## Department initiated Amendment

<b>Licence Number</b>	L8410/2009/2
<b>Licence Holder</b>	WA Composts Pty Ltd
<b>ACN</b>	078 383 856
<b>File Number</b>	APP-0032114
<b>Premises</b>	C-Wise 230 Gull Road NAMBEELUP WA 6207  Legal description – Part of Lot 89 on Plan 741 Certificate of Title Volume 1112 Folio 243  As defined by the coordinates in Schedule 2 of the Revised Licence
<b>Date of Report</b>	12 December 2025
<b>Decision</b>	Revised licence granted

## 1. Decision summary

Figure 2. Proposed layout of hardstand, leachate system and header tanks

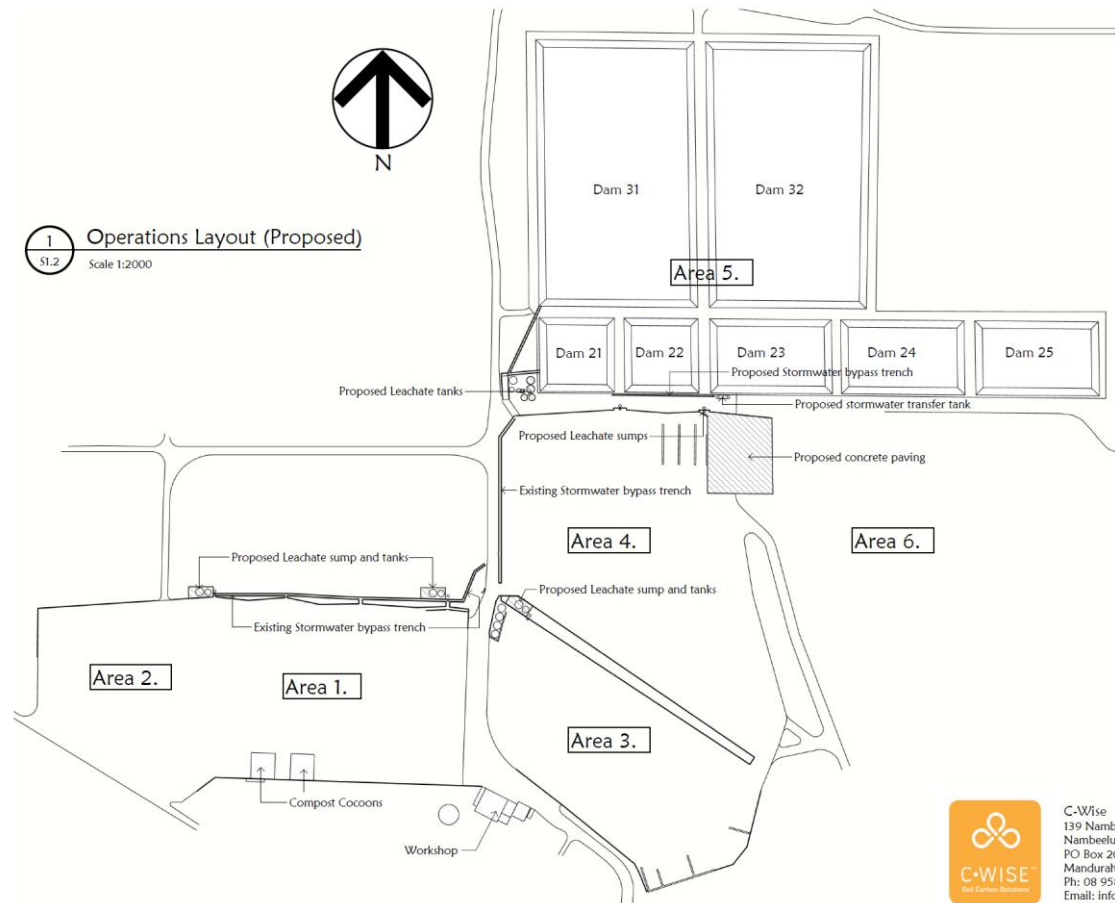
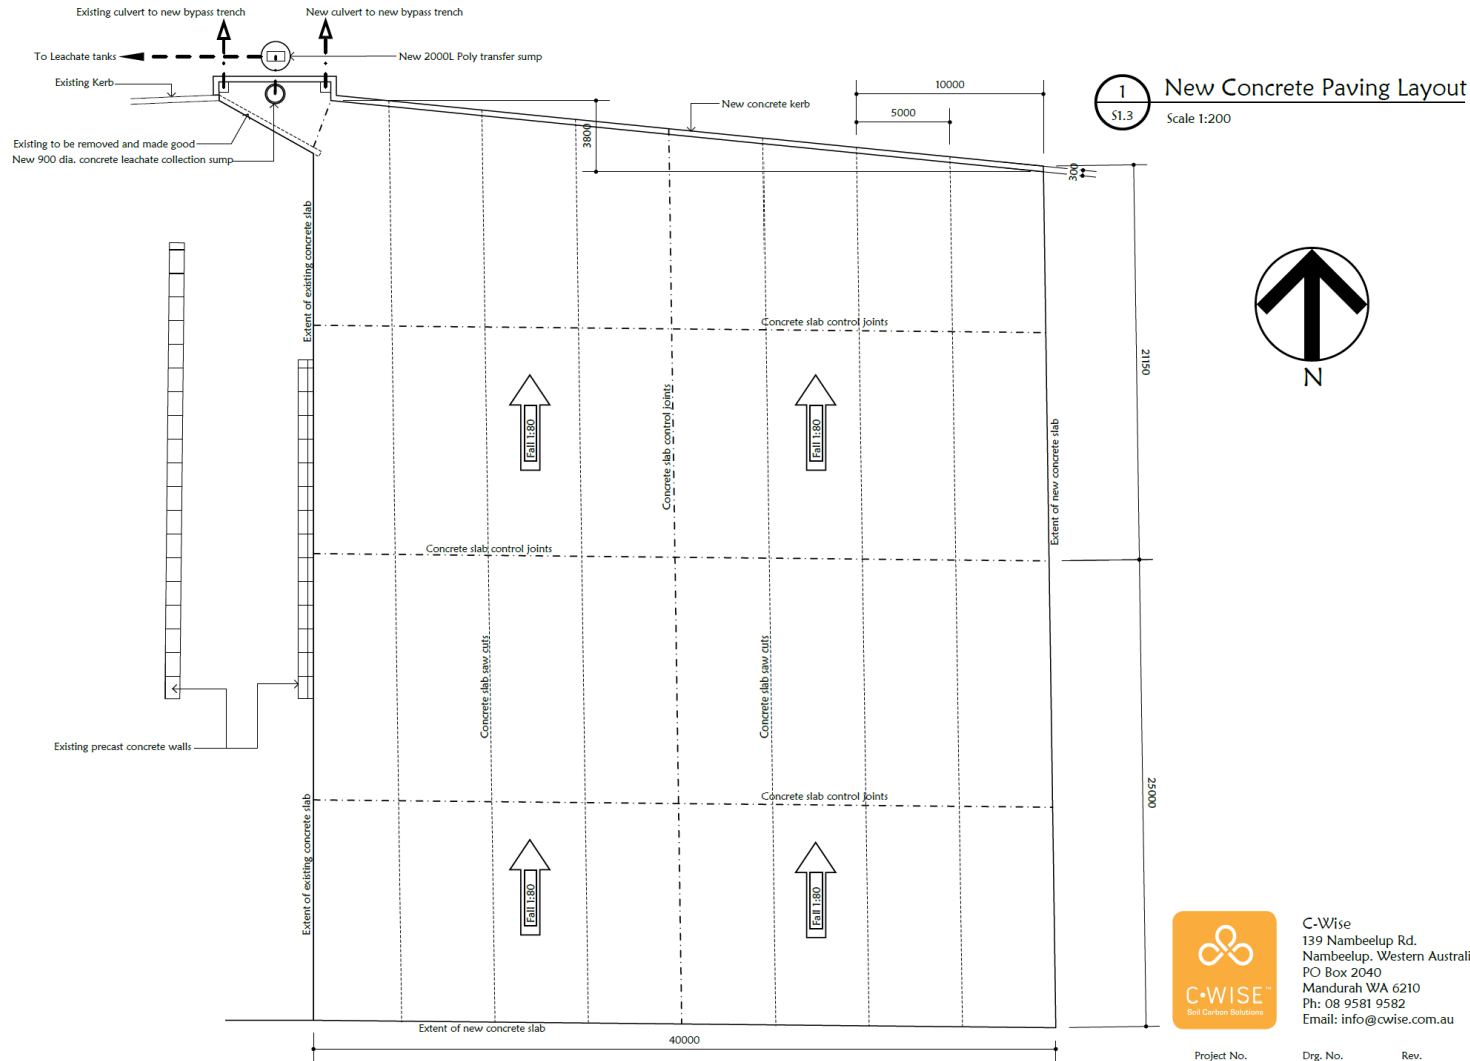
### ***Hardstand extension***

The licence holder has proposed that the additional hardstand area will improve the management of solids and liquids incorporation through the extra space available.

Appendix 2, Figures 2 and 3 provides a preliminary concept of the proposed hardstand extension.

Figure 4. Proposed leachate sump and tank design

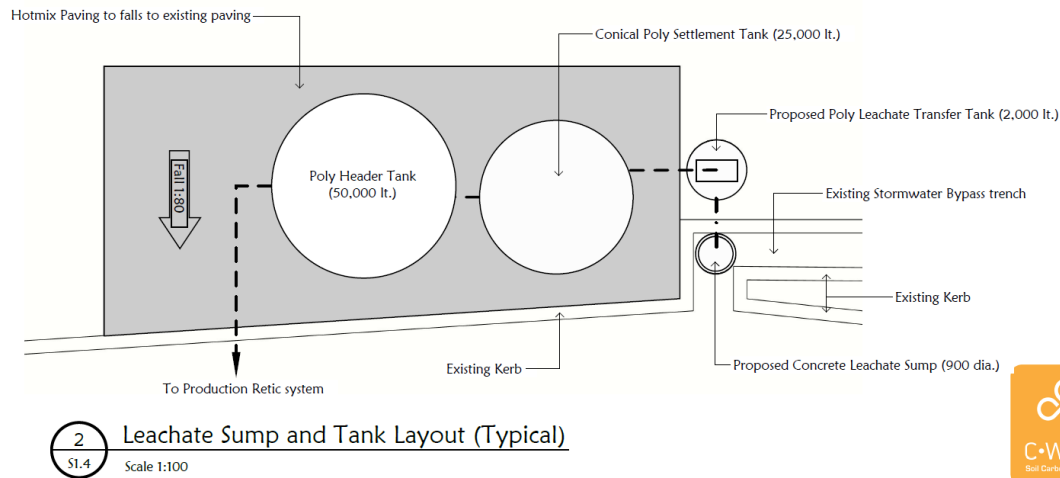
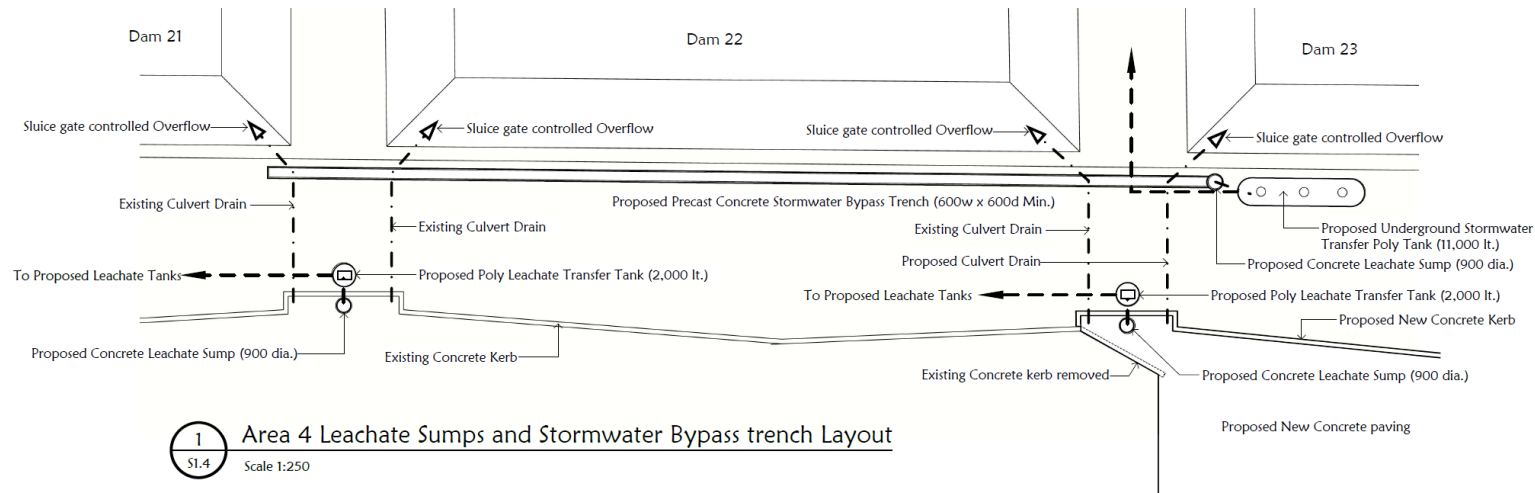
### ***Leachate collection sumps***

Currently, leachate drains capture leachate runoff from the composting hardstand areas and direct the liquid back into the pond system, creating extra volume of liquids within the ponds. The installation of leachate sumps will allow the capture of all leachate runoff from the hardstand areas, with the leachate then recirculated into the composting process, bypassing the need to utilise the pond system. The Delegated Officer considers that the reduced volume of leachate entering the pond system will reduce odour emissions generated by the ponds.

Appendix 2, Figures 3 and 4 provides a preliminary concept of the leachate collection system.

### ***Header tanks***

With the installation of the leachate sump network, the leachate can be pumped into the header tanks. This will allow the separation of leachate and washdown liquids, reducing the volume of liquid required for recirculating into the early stage composting process. The Delegated Officer considers that the storage of leachate within the enclosed tanks, rather than the pond system, will reduce odour emissions generated by the premises.

Appendix 2, Figures 3 and 4 provides a preliminary concept of the leachate tank system.
